KLEEN-PRO spot. s.r.o.									
2 AIR LIQUIDE		MAINT. ZONES DATE : ULL. ZONES		INS-SPK INS-SPK INS-SPK		INS-SPK INS-SPK INS-SPK			
Air Liquide AG GmbH		Job code: K 70101		Reference: ASU No.9 KOISCE		Title: WPC ROOM 180, ELECTRICAL ROOM 180 Wires system shutdown Drilling of support foundations			
Repairs: 79, _____ Replaced by: 79, _____		Scale 1:50		Original format DIN A4		Signature, name, address of architect History file: _____		A 0	
		Drawing No.: 792.87671		Sheet: --- of --- Sheet		Rev		A

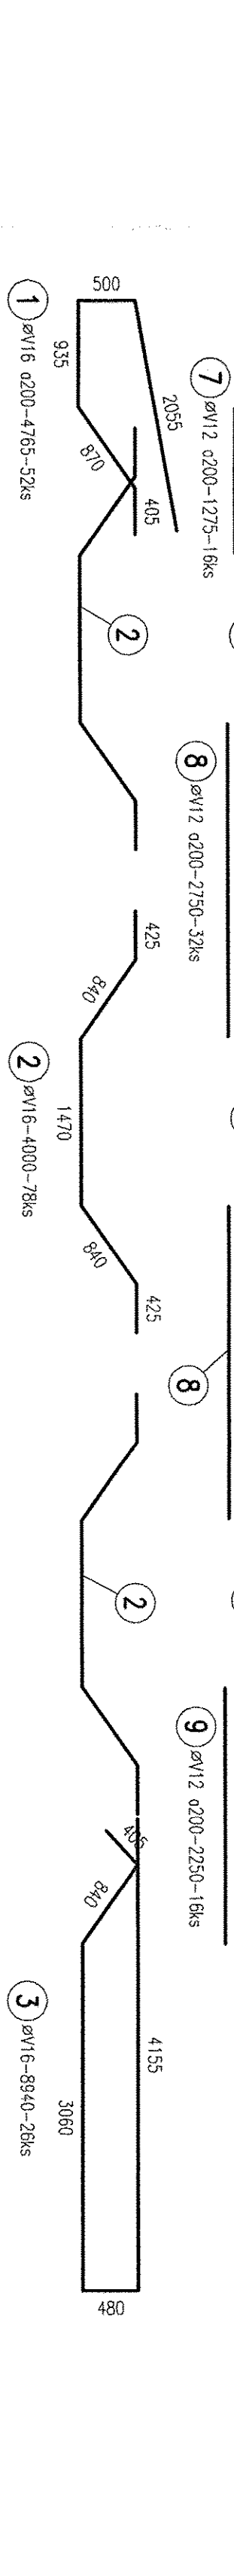
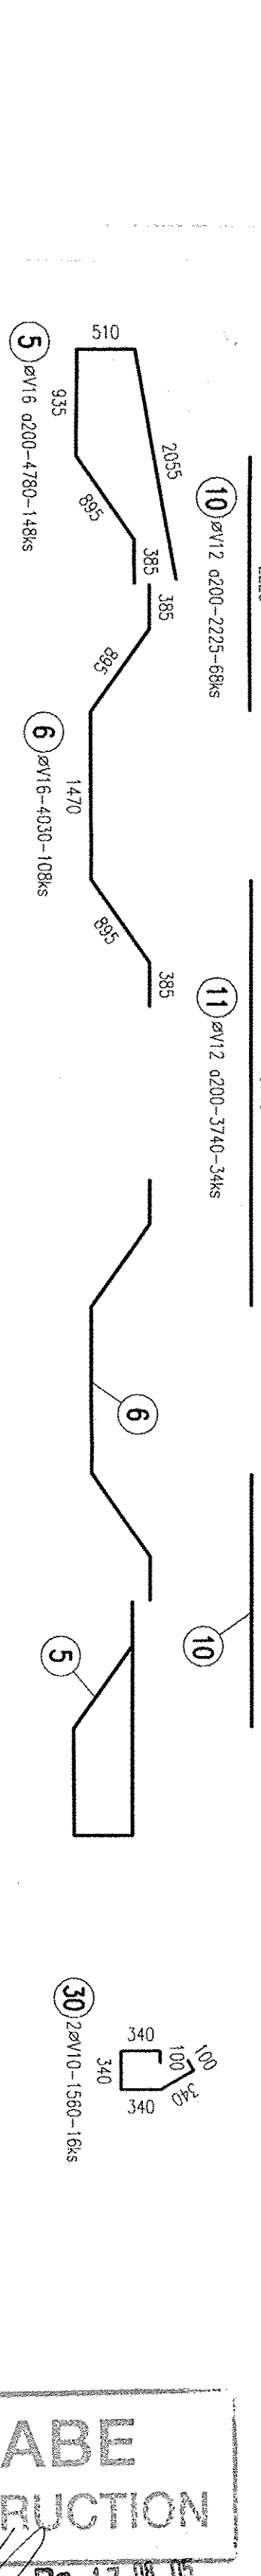
ZMENA "A" / CHANGE "A"
doplnenie výstuže zidkovej dosky / addition of concrete deck's reinforcement
konštrukčnou (dizajnovou) výstužou zidkovej dosky / constructional (superficial) reinforcement
deska hr. 250 mm
300x300
200x100
100
0,8 x 2,25 x 0,517 = 130,5 kg
0,10-0,00-2,515 = 264/m²
desa s výš. 300
550x550
100
0,10-0,00-3,25 = 464/slp
1,6 x 3,2 x 0,617 = 316,6 kg
